## HISTORIC AND DESIGN REVIEW COMMISSION

**HDRC CASE NO:** 2016-294  
**ADDRESS:** 626 AVENUE E  
**LEGAL DESCRIPTION:** NCB 443 BLK 5 LOT 1  
**ZONING:** FBZ T4-2 HS  
**CITY COUNCIL DIST.:** 1  
**LANDMARK:** Schiebel / Richardson House #1  
**APPLICANT:** John Speegle/Speegle & Kim-Davis Architecture  
**OWNER:** John Speegle/Speegle & Kim-Davis Architecture  
**TYPE OF WORK:** Conceptual approval of a rear addition  
**REQUEST:**

## **“Addition to Schiebel-Richardson” Residence** **626 Avenue E, San Antonio, Texas 78215**

# EXISTING & PROPOSED CROSS-SECTIONS

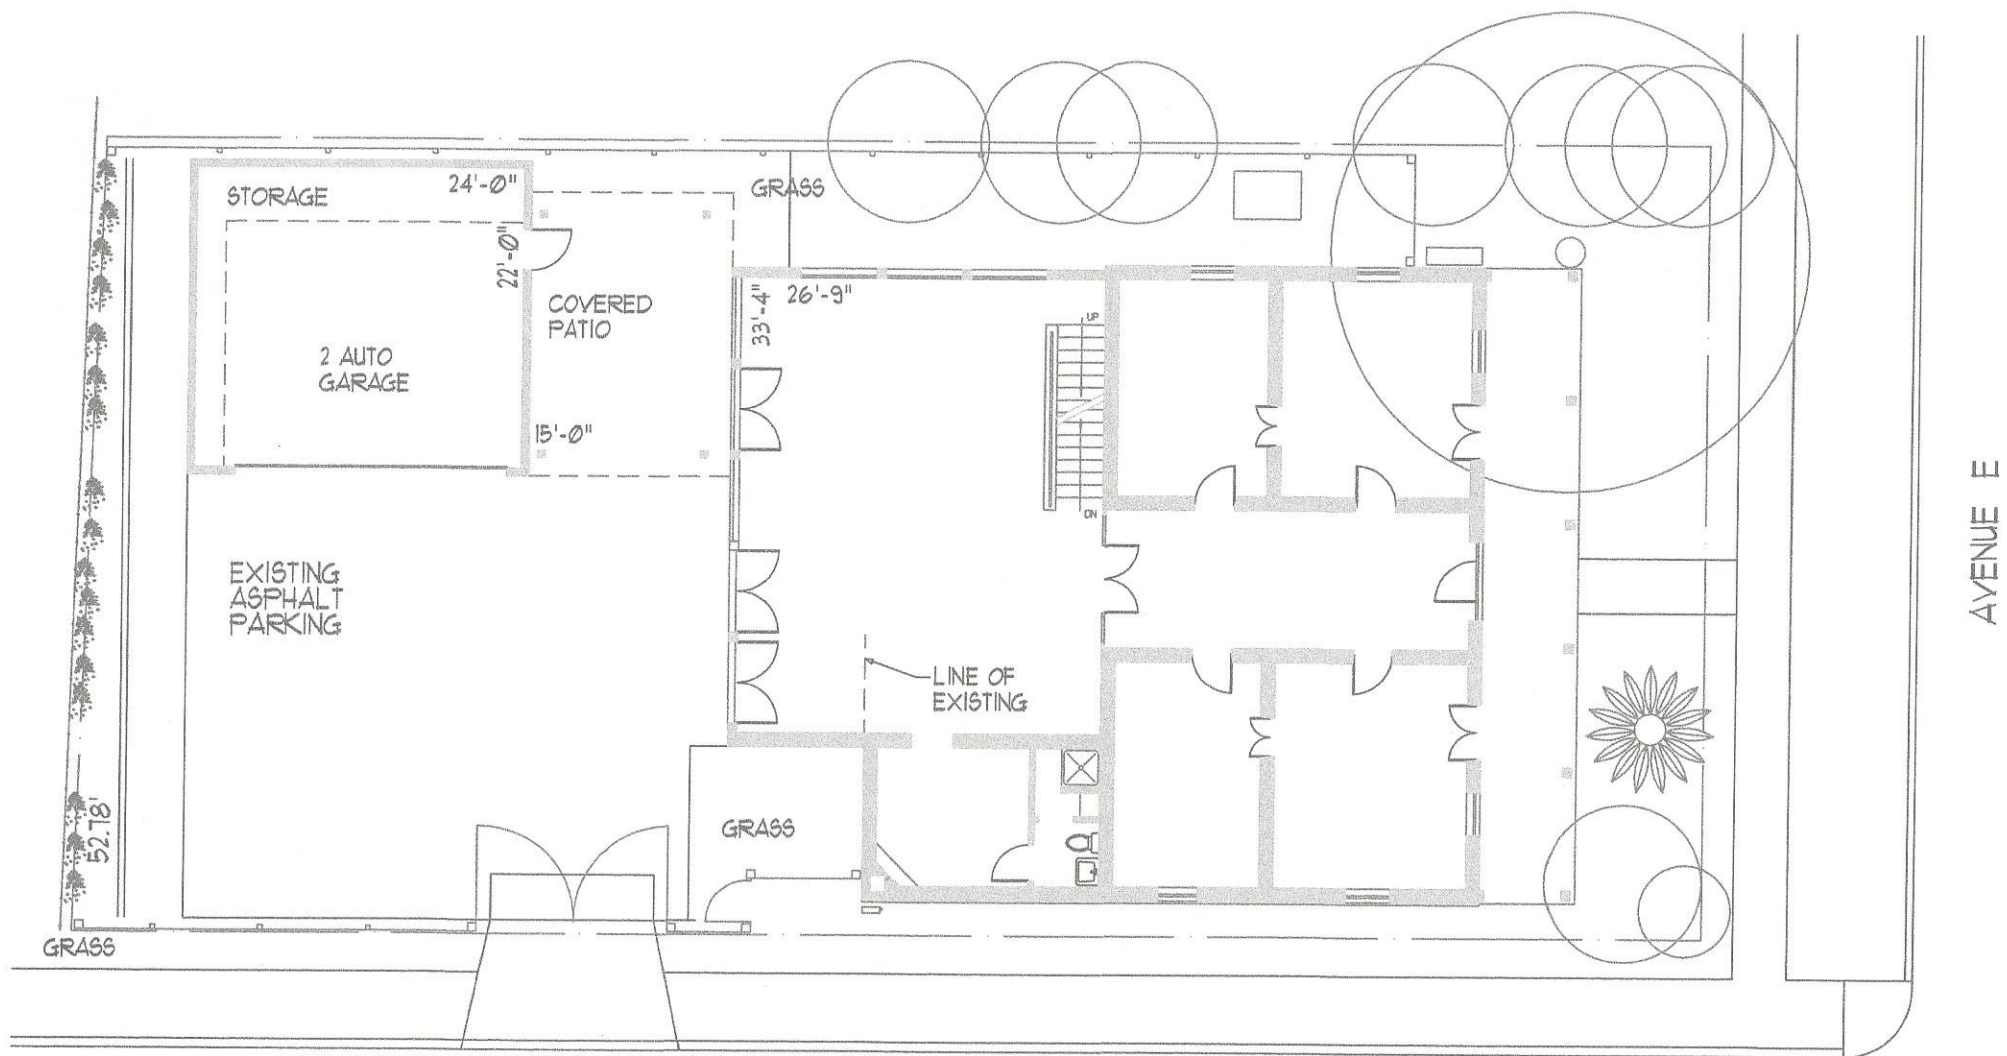
- c. **ADDITION** – In the immediate vicinity of 626 Avenue E, there are few historic structures that feature a similar architectural style and massing as the original structure. Additionally, this structure is located surrounded by commercial and industrial structures. The applicant has provided a line of sight study noting that the proposed addition will not be seen from the sidewalk at the public right of way on Avenue E. Staff finds the request for a two-story addition appropriate in regards to the context of the block. The applicant has proposed for the addition to feature 1x6 inch stained vertical siding. The applicant’s proposal is consistent with the Guidelines for Additions 1.A.

- d. **SCALE, MASSING & FORM** – Regarding scale, massing and form, the applicant has proposed for the addition to feature comparable floor to ceiling heights as the primary historic structure. This is consistent with the Guidelines for Additions 1.A.

# PROPOSED SITE PLAN

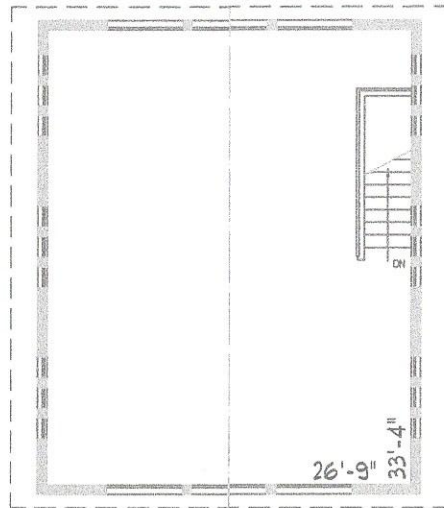
- g. **GARAGE** – At the rear of the property, the applicant has proposed to construct a garage to accommodate parking for two automobiles. The applicant has proposed for the garage to feature materials matching those of the proposed addition. Regarding the location of an accessory structure, the applicant has located the proposed garage in an appropriate location and has proposed an appropriate massing. This is consistent with the Guidelines for New Construction.

- h. **COVERED PATIO** – To connect the proposed garage to the proposed addition, the applicant has proposed to construct a covered patio to feature an overall height less than that of the proposed garage. Additionally, the applicant has proposed massing that does not present domination on the lot. Staff finds the proposed covered patio appropriate and consistent with the Guidelines.
